GNRO-2014/00045

SUBJECT: Response to Request for Additional Information Regarding Maximum  
Extended Load Line Limit Plus Amendment Request, dated 5/19/2014.  
Grand Gulf Nuclear Station, Unit 1  
Docket No. 50-416  
License No. NPF-29

**RESPONSES TO REQUEST FOR ADDITIONAL INFORMATION DATED 5/19/2014**  
**PERTAINING TO LICENSE AMENDMENT REQUEST – MAXIMUM EXTENDED LOAD LINE**  
**LIMIT PLUS**

Figure 2.1. Graphical Depiction of the SLMCPR Evaluation Statepoints

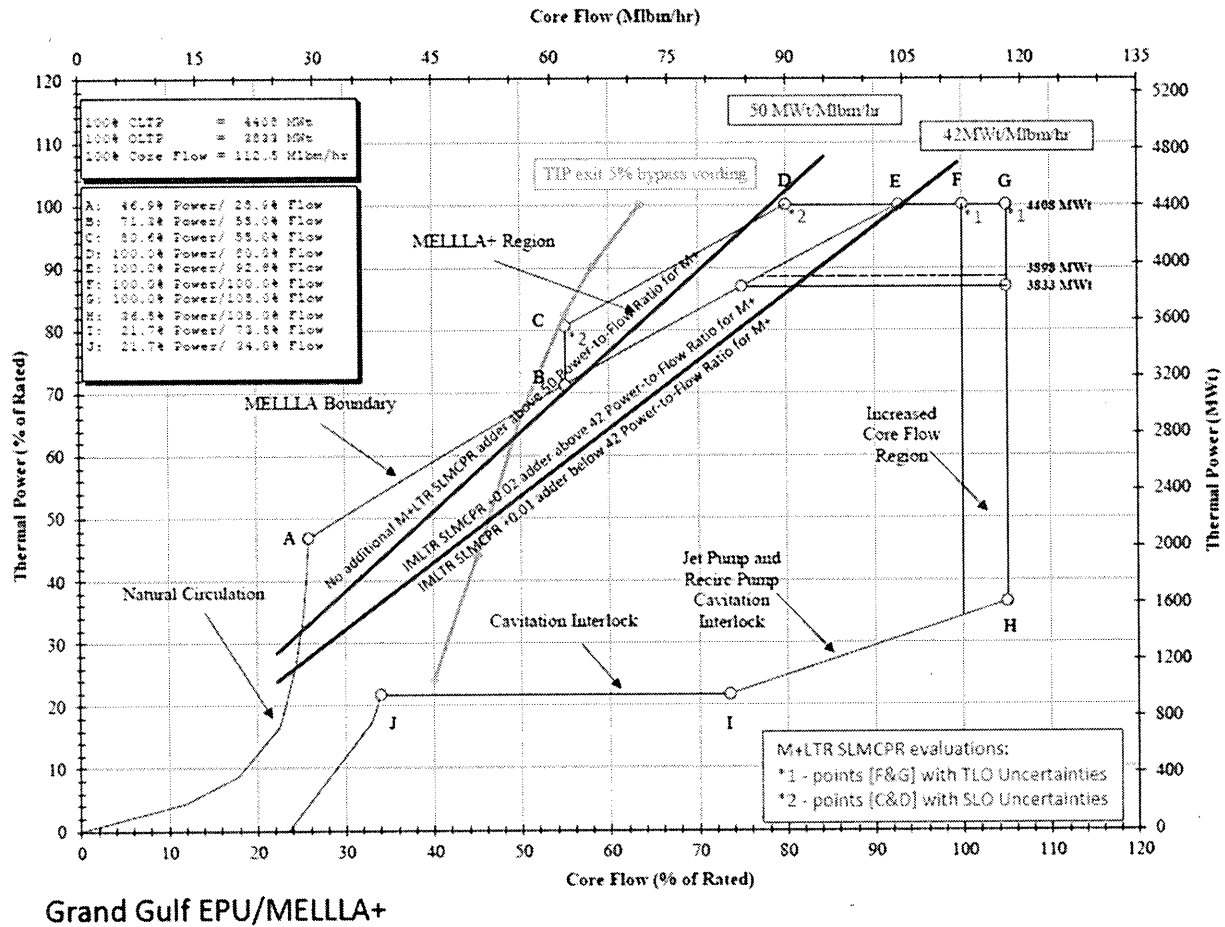
Section 2.2.1 “Safety Limit Minimum Critical Power Ratio” states that “a +0.02 SLMCPR adder will be added to the cycle-specific SLMCPR.”

1. Provide a list of SLMCPR adders in MELLLA+ with respect to Operating Licensed Thermal Power (OLTP) conditions.
2. Specify which adders are part of the Extended Power Uprate (EPU), and which are MELLLA+ specific.

Figure 2.1 shows a graphical depiction of the SLMCPR evaluation statepoints and the Methods LTR penalties applied based on Power-to-Flow Ratio. Statepoints C&D [\*2] in Figure 2.1 apply a +0.02 SLMCPR adder. Statepoints F&G [\*1] in Figure 2.1 apply a +0.01 SLMCPR adder.

The most limiting SLMCPR of the four evaluation statepoints at BOC/MOC/EOC cycle exposure conditions will be used to set the technical specification SLMCPR. It is anticipated that MELLLA+ plants, will have the TLO SLMCPR and SLO SLMCPR be set equivalent in the technical specifications to avoid a SLO SLMCPR lower than a TLO SLMCPR.

**Figure 6.1. Typical Separator Performance Characteristics with Core Effects Omitted**

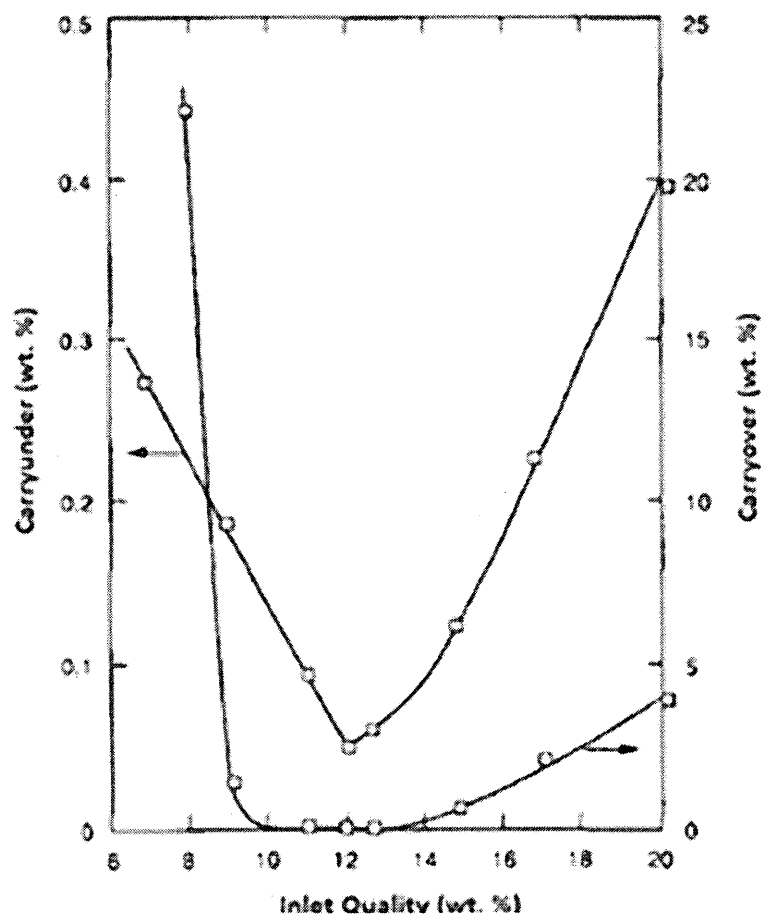
- 1. What analyses were performed to determine the 0.33% permissible limit?*
- 2. What analyses were performed to determine the 0.2% MCO under MELLLA+ conditions?*
- 3. What plant operations are used in GGNS to minimize the MCO?*
- 4. Provide a short physical explanation of what causes the increased MCO at lower flow. Is this mechanism predicted using an experimental correlation or a first principle analytical tool?*
- 5. How is the MCO monitored during operation? What is the typical surveillance period?*

Separator performance is primarily affected by three parameters: (1) the immersion water level surrounding the separators; (2) the total mass flow rate passing through the separator; and (3) the inlet quality. Neglecting changes in the water level, which does not change during steady-state operation, optimal separator performance with regard to separator carryover (CO, defined as the amount of moisture in the steam exiting the separator) occurs over a relatively narrow band of steam separator inlet quality ranging from roughly 10 to 25 wt. %. This performance characteristic is illustrated by typical test results of CO versus Inlet Quality of the steam entering the separators at a constant inlet flow rate shown in Figure 6.1. CO increases rapidly when the inlet quality lies outside this optimal range, even at higher inlet qualities, despite the decreasing moisture content of the steam. Increases, or decreases, in core flow rate affects both the mass flow rate through the steam separator and the steam separator inlet quality. Increases, or decreases, in steam separator inlet quality outside the optimal band will increase CO, the amount of moisture that the steam dryer must remove.

The separators were designed for a specific range of inlet qualities and mass flow rates. At higher steam qualities exiting the core, the swirl vane design is not as effective in providing enough centrifugal force to the steam flow to remove sufficient water content to meet the original design values and thus more water passes through the separator to the dryer. If a significant number of the separators are affected in this way, high MCO conditions ( $>0.10$  wt. %) can result. The GGNS-specific MELLLA+ evaluation, which is a hardware design basis evaluation that incorporates additional margin into the analysis for conservatism, indicated the potential for several separators to operate with elevated separator CO under MELLLA+ conditions. If the performance of a sufficient number of separators is such that they are passing high CO, the increased moisture may exceed the local capacity of the dryer to remove the additional moisture due to localized flooding of the vane channels. This condition is known as moisture breakthrough and is characterized by an abrupt increase in the moisture content of the steam exiting the dryer (i.e., MCO) above the original functional dryer performance specification of 0.10 wt. %.
